IM 0702-257
15195
I-70 EJMT Resurfacing

DATE: February 09, 2006

SUBJECT: Revision No. 1 (to be acknowledged in all bid proposals)

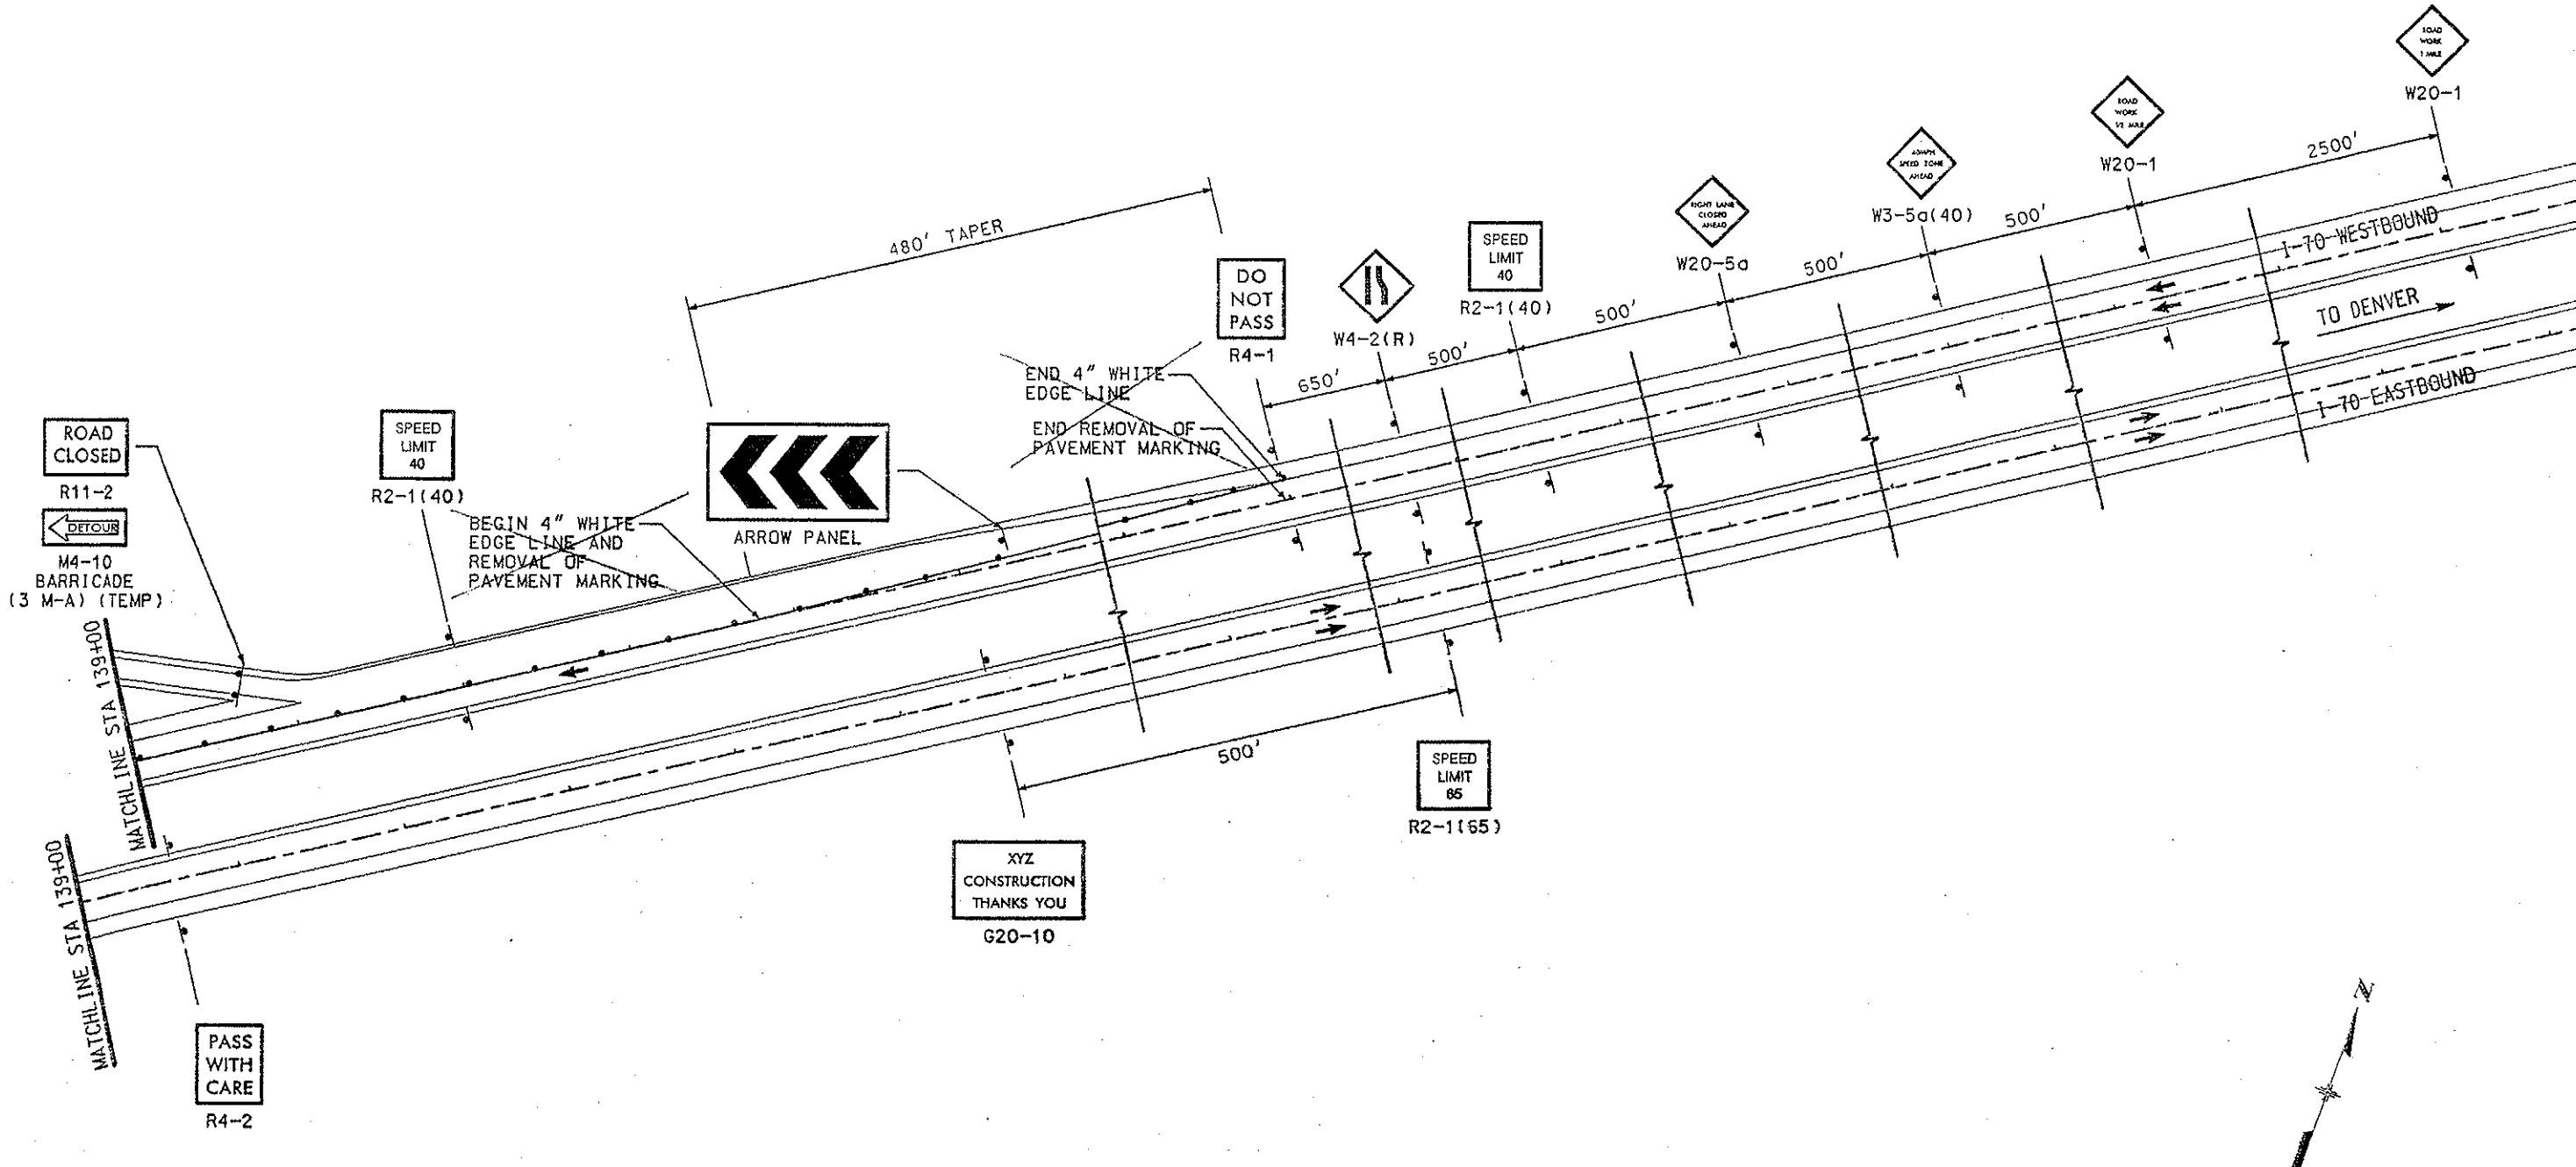
Sheet 1: Updated Revision Block
Sheet 10: Changed Quantity
Sheet 12: Changed Quantity
Sheet 15: Changed Quantity
Sheet 61: Updated Item Name
Sheet 64: Updated Item Name
Sheet 66: Updated Item Name
Sheet 71: Updated Item Name
Sheet 76-80: Added Sheets for Information Only
